**PLANNING DEPARTMENT ADMINISTRATIVE PUBLIC HEARING  
SUMMIT COUNTY, UTAH  
June 4, 2026**

- 1.A. **841 Lowell Avenue – Historic District Design Review** – The Applicant Proposes a New Single-Family Dwelling on a Non-Historic Site in the Historic Residential - 1 District. PL-26-06903  
(A) Public Hearing; (B) Action

**Subject:** 841 Lowell Avenue Lot 9  
**Application:** PL-26-06903  
**Author:** Meredith Covey, Planner II  
**Date:** June 4, 2026  
**Type of Item:** Historic District Design Review

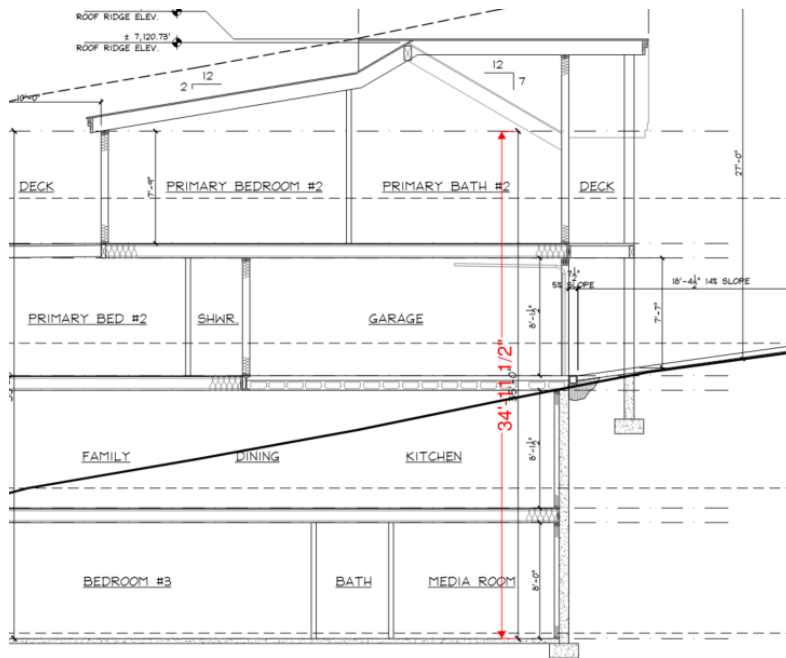
Maximum interior height of 35 feet, measured from the lowest finished floor plane to the point of the highest wall top plate that supports the ceiling joists or roof rafters

**Complies:** The proposed maximum interior height of the Structure is 35 feet, measured from the lowest finished basement floor to the highest wall top plate.

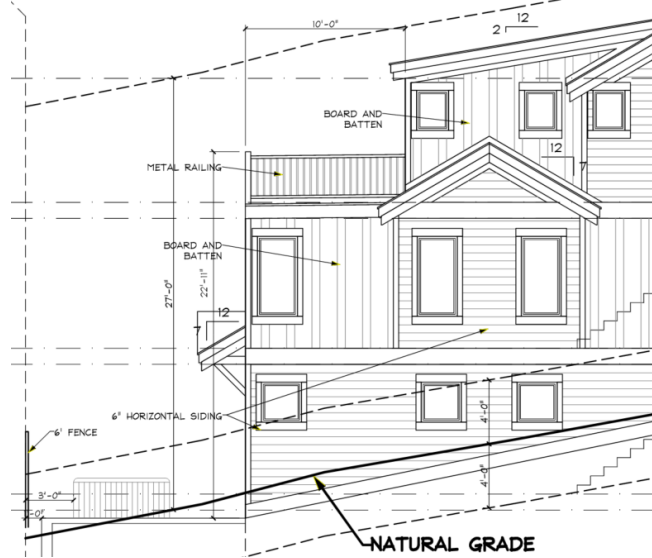
A ten foot (10') minimum horizontal step in the downhill façade is required. The horizontal step shall take place at a maximum height of twenty-three feet (23') from where the

**Complies:** The Applicant proposes a 10-foot horizontal stepback on the rear, downhill façade at a vertical height of 22 feet, 11 inches:

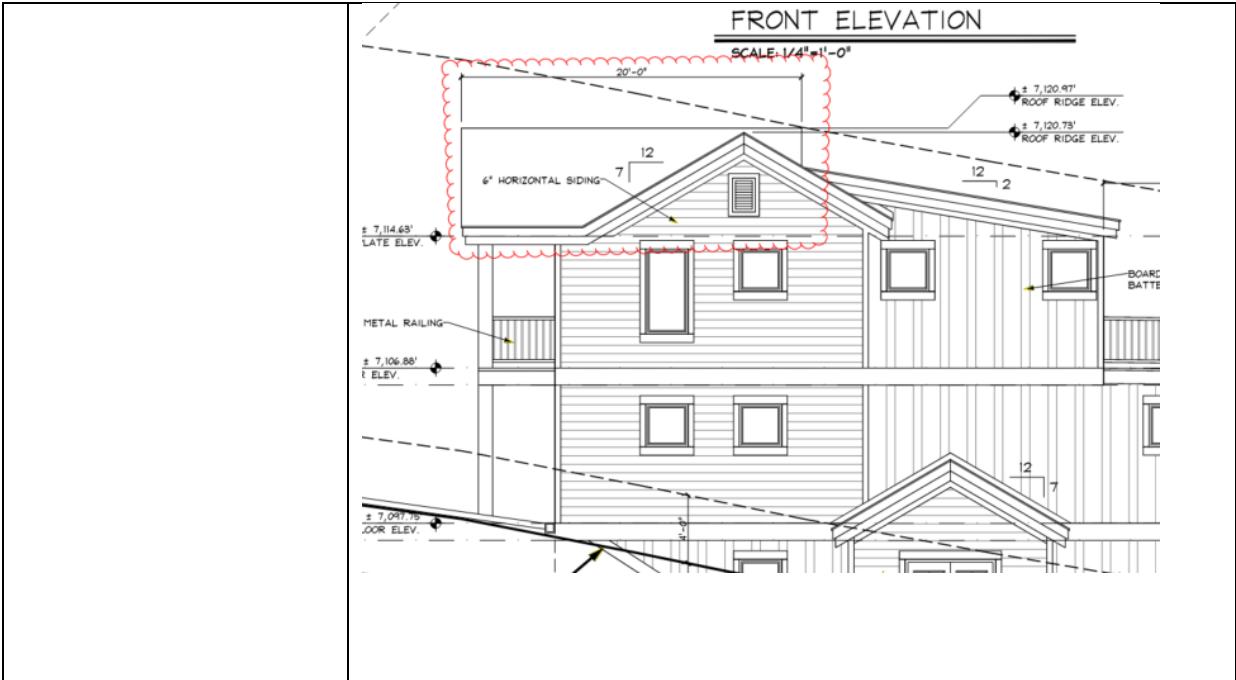
When viewed from the primary public Right-of-Way, the contributing roof form is a 10:12 pitch:

The 10:12 Contributing roof form occupies a horizontal distance of 20 feet back from the primary façade to the rear of the building when viewed from Lowell Avenue:

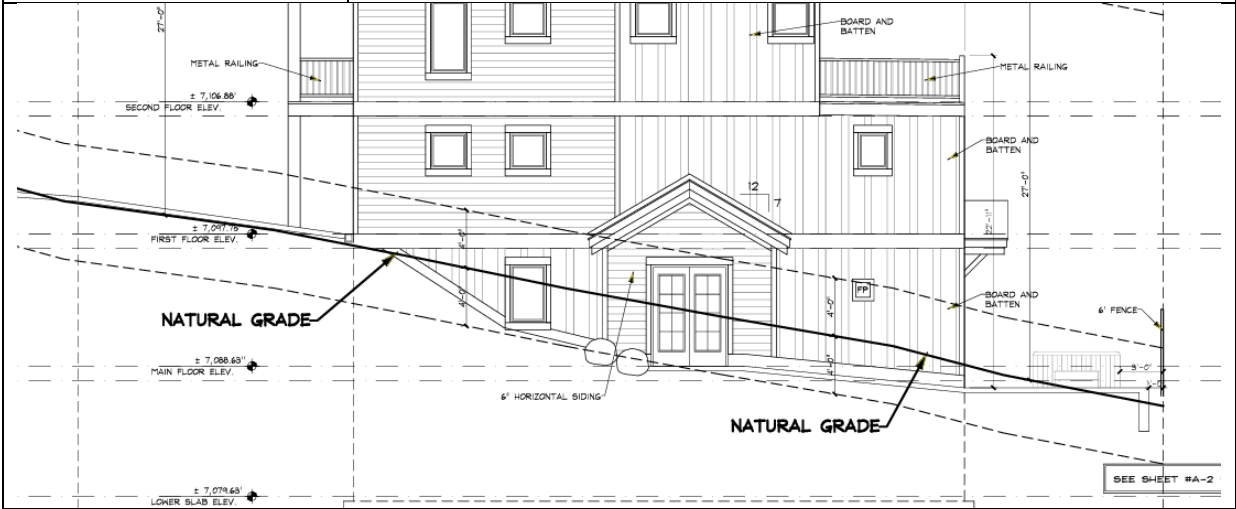
Final Grade within 4 feet of Existing Grade

**Complies:** The Applicant was issued a Determination of Interpolated Grade by the Planning Director on October 14, 2025 (Exhibit B). The proposed Final Grade is within four feet of existing grade as shown below:
